AMENDMENT No.1 (Commercial)

E- Tender No.: SJVN/CHQ/ECD/SUNNI/EMP/2024

Name of Tender: **Electro-Mechanical Works of Sunni Dam HEP (382 MW) located in Distt. Shimla and Mandi in Himachal Pradesh (India).**

DESIGNED: SRN	SCALE: 1: 1500	FORMAT: A1
DRAWN: DSR	[1: 3000]	[A3]
CHECKED: TSK	DRAWING No.	REV No.
APPROVED: SSE	AFRY.5002.00.001	5
DATE: 15.03.23

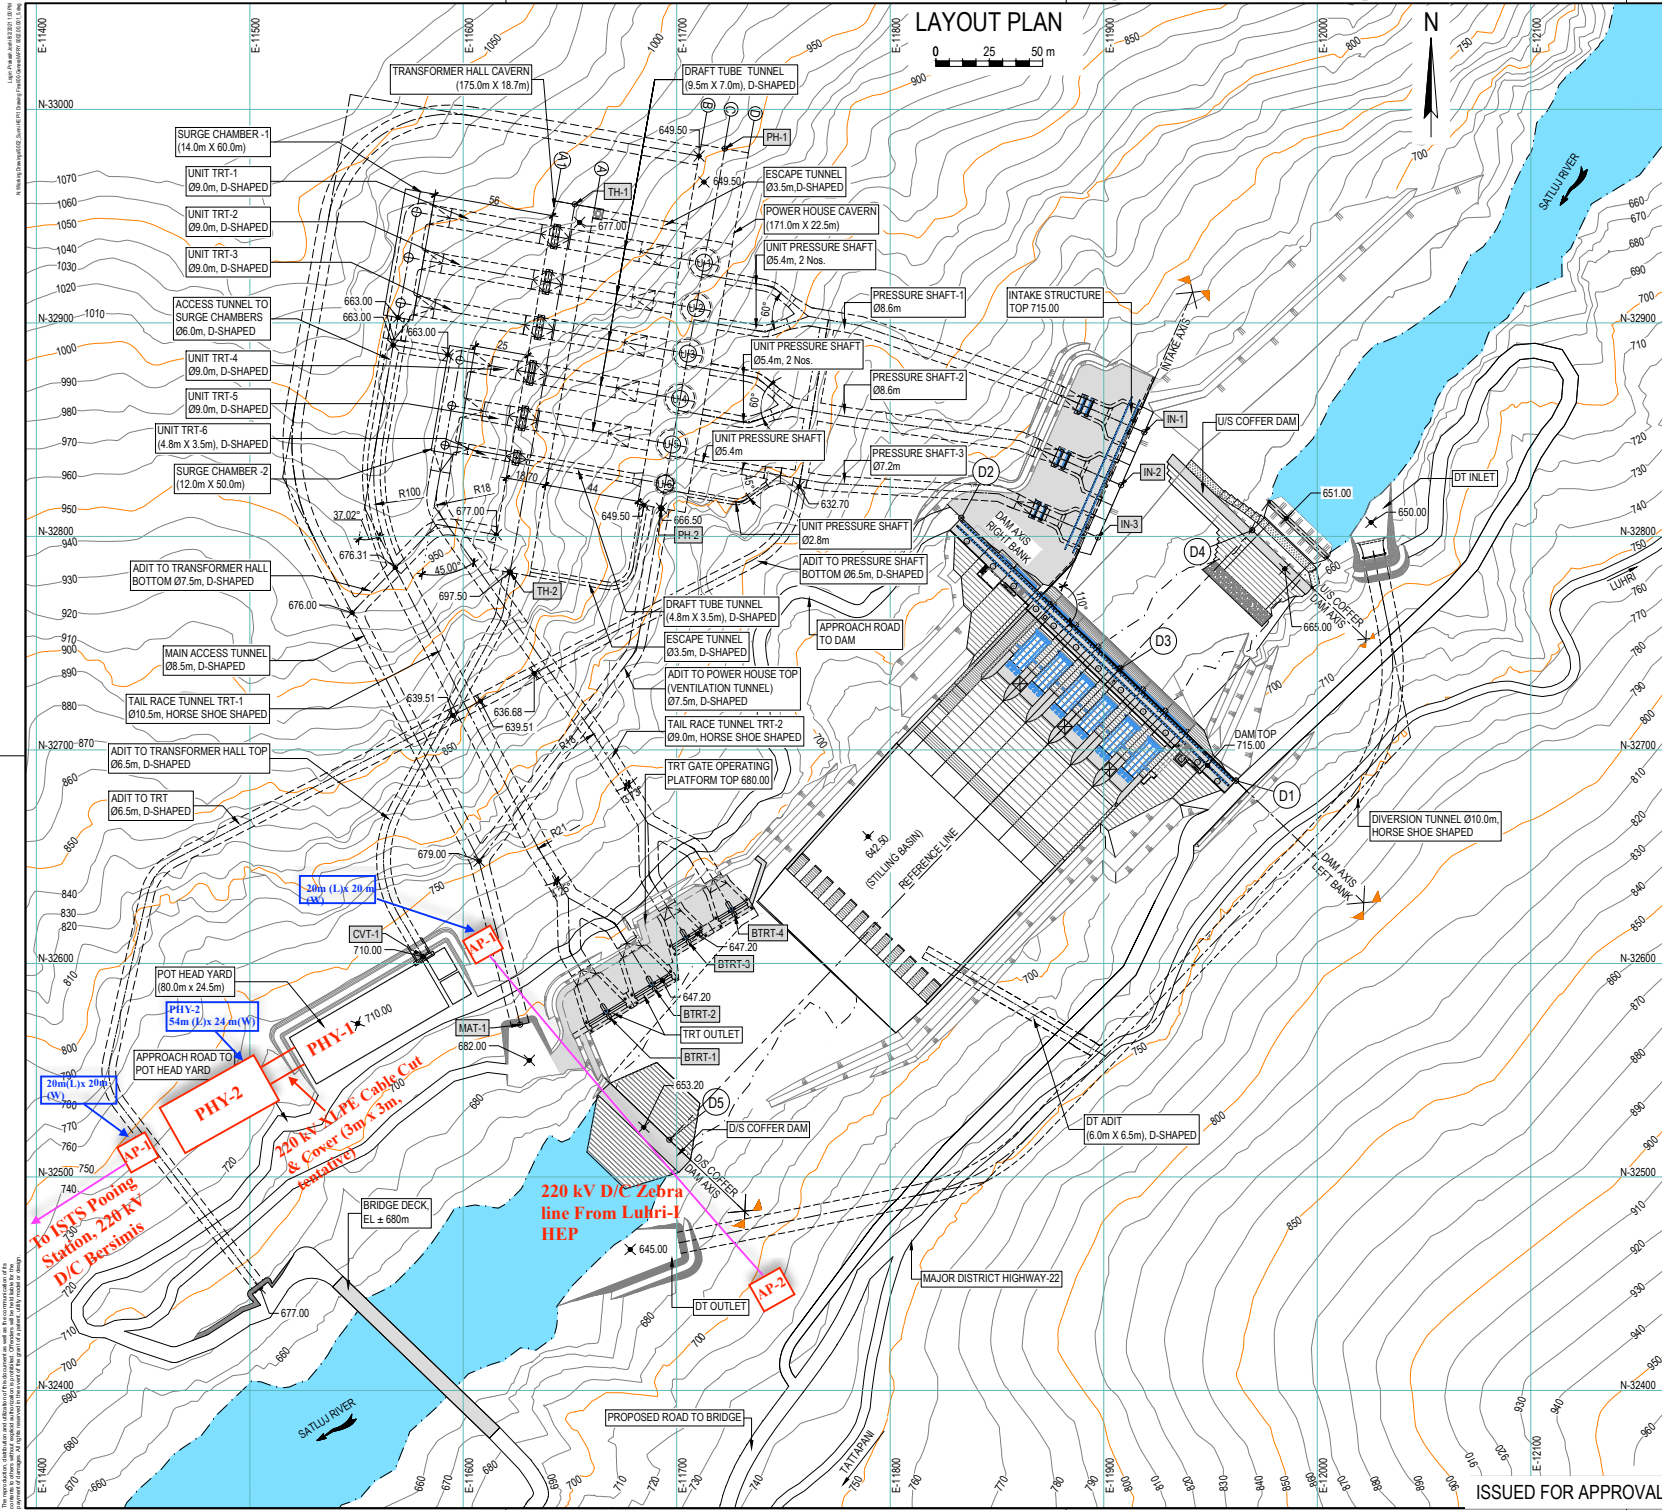
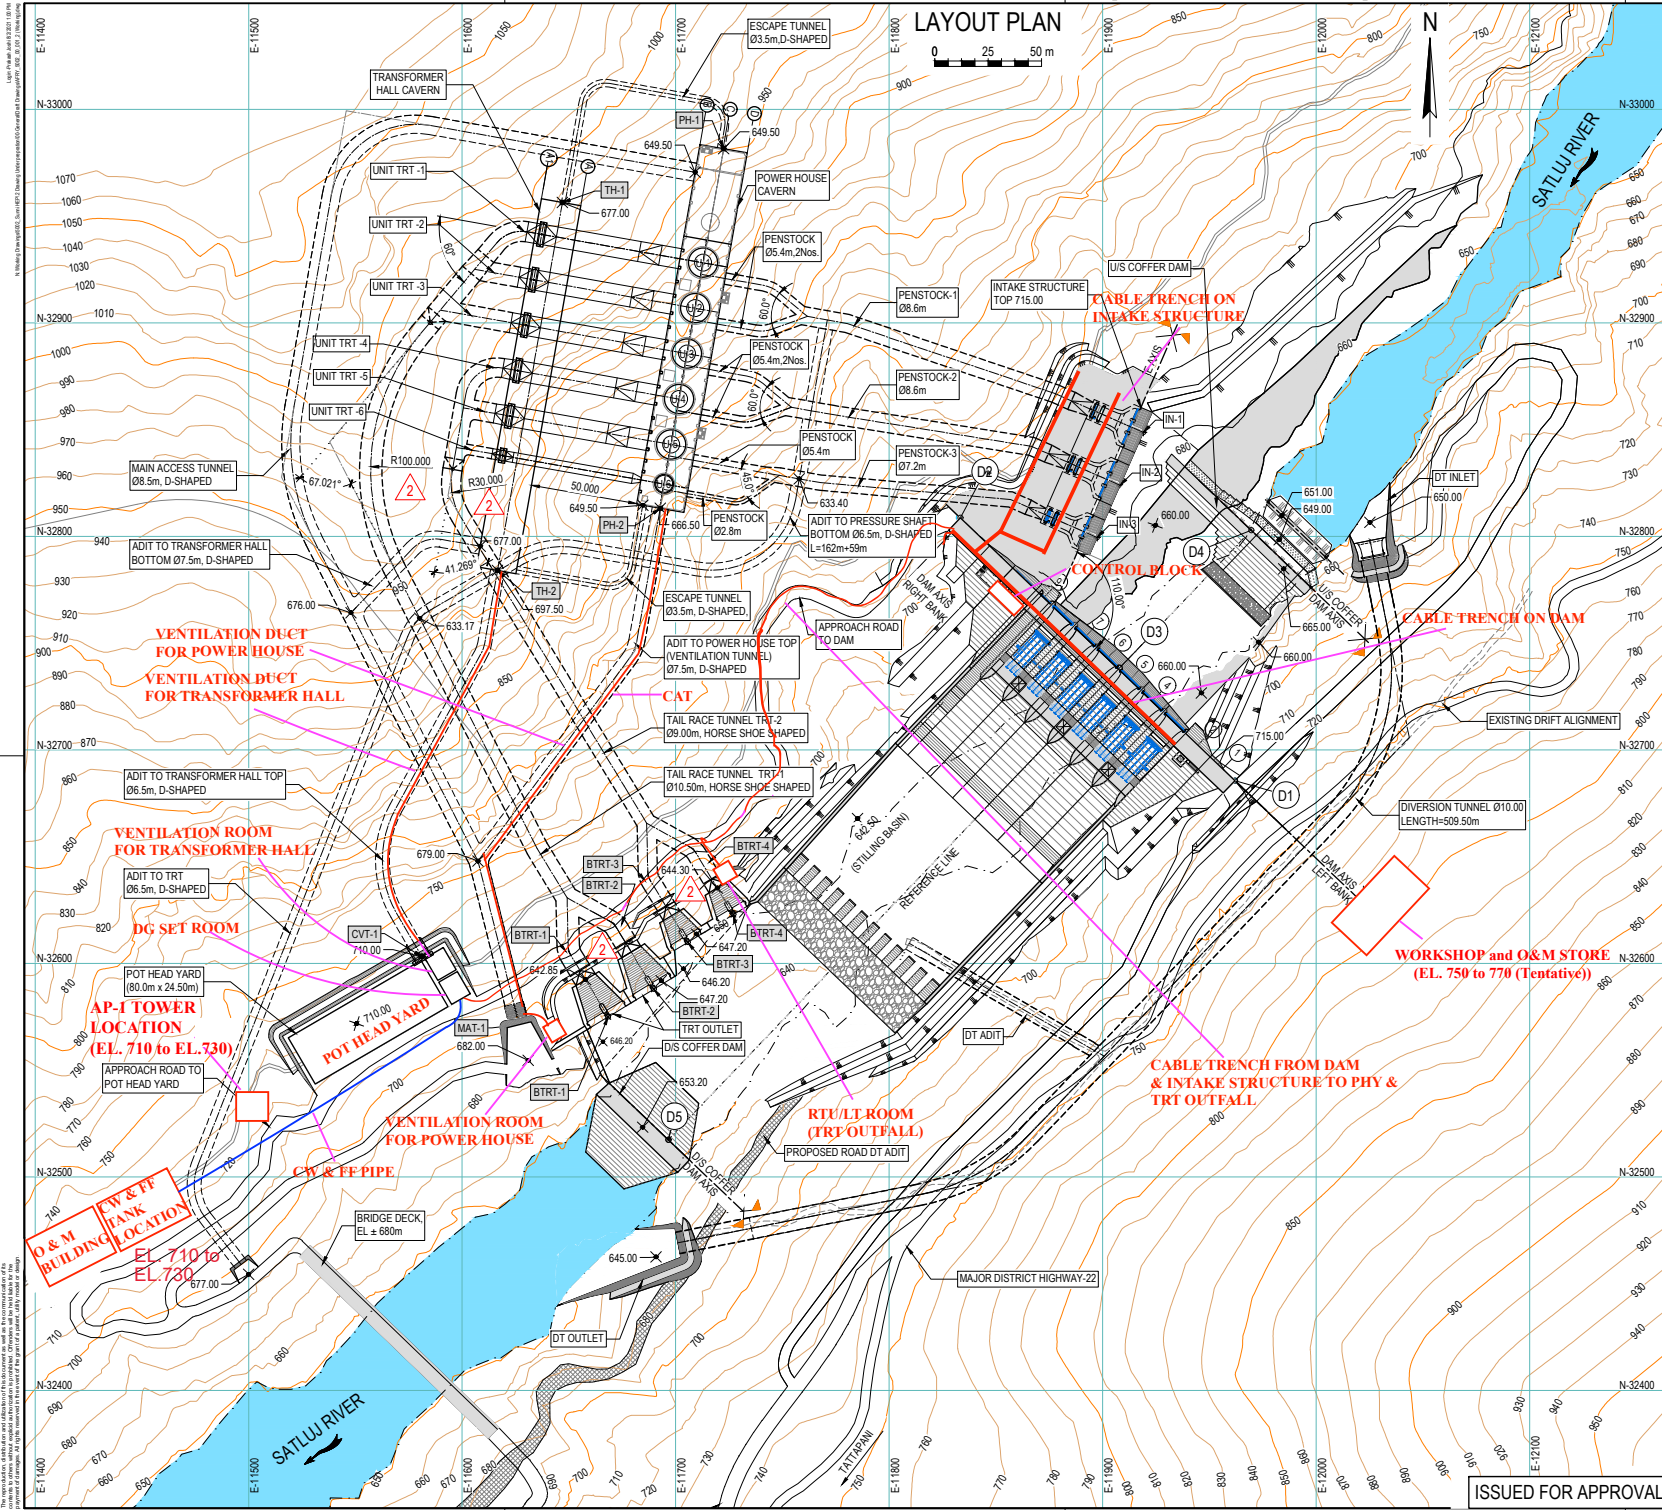
11	14.0 Protection	Clause 14.3.2 (a-7)	Check Synchronizing Relay	Check synch relay for line breakers can be part of Distance protection. But for closing of buscoupler also check synch function to be considered in separate relay.Further separated Check Synch relay for line and Buscoupler shall be required for closing of C.B from OWS of CMS.
12				
13	8. Generator & Associated Aux	SCHEDULE OF MAND. SPARES	Schedule-III amended and enclosed.
14		8.3.1	Generator Shaft Material ASTM A 668	Generator Shaft Material ASTM A 668 Grade D
15		Clause 18.1.1.1	Please refer amended GAD Drawing no AFRY.5002.00.001 for distances. OFC to be routed in trenches.

16	18. LV, MV Cable and Cable Trays	Clause 18.1.1.1 & 18.1.1.2	<p>1. Power Cables: vi. One (1) lot of power cables from EM panels to third party interface such as Hydro-mechanical equipment, civil infra equipment (ejector, water purification plant etc.) Load list of third-party equipment shall be as per Annexure-1 of this section.</p> <p>2. Control and Instrumentation Cables: iv. One (1) Lot of control cables from EM panels to third party interface such as hydro-mechanical panels, FOTE panels of Associated Transmission system (ATS). (Refer Annexure-1 of this section).</p>	Load requirement for third party panels attached as annexure-A
17	27. DG Sets	Clause 27.3.1 ii	Class of Insulation F	Insulation class of H.
18	15. Control & Monitoring Ssystem	Clause 15	GAD Drawing No. AFRY.5002.00.001	Please refer GAD No. AFRY.5002.00.001. for various Route Distances

220V
MAIN DCDB-1/2

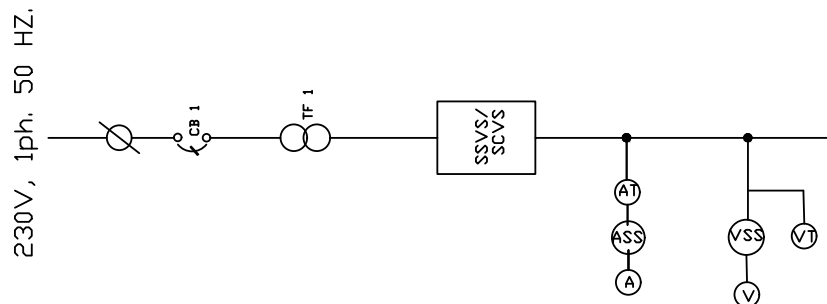
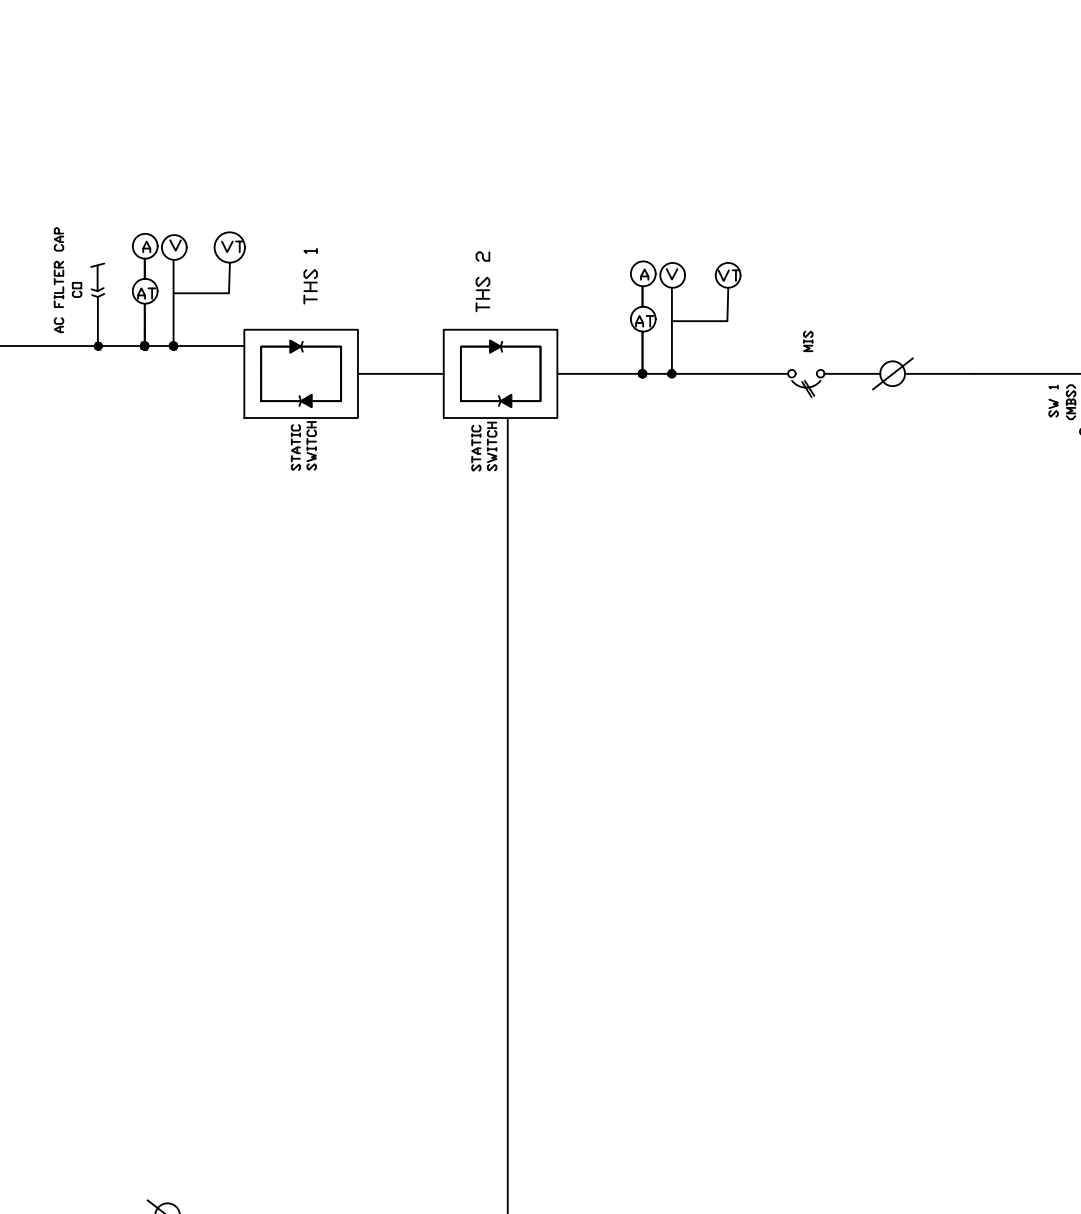
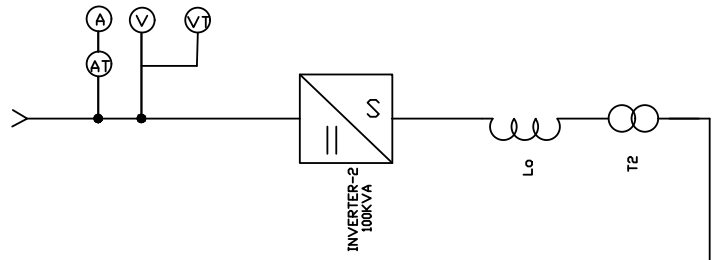
1. ABOVE SCHEME IS FOR ESTIMATION PURPOSE ONLY. FEEDER RATINGS & QUANTITIES SHALL BE FINALIZED DURING DETAIL ENGINEERING AS PER SYSTEM REQUIREMENT.
2. MINIMUM 20% SPARE DC FEEDERS FOR EACH SIZE SHALL BE KEPT AS SPARE & MINIMUM ONE.
3. ALL TRANSDUCER SHALL PROVIDE ANALOG INTERFACE TO SCADA.
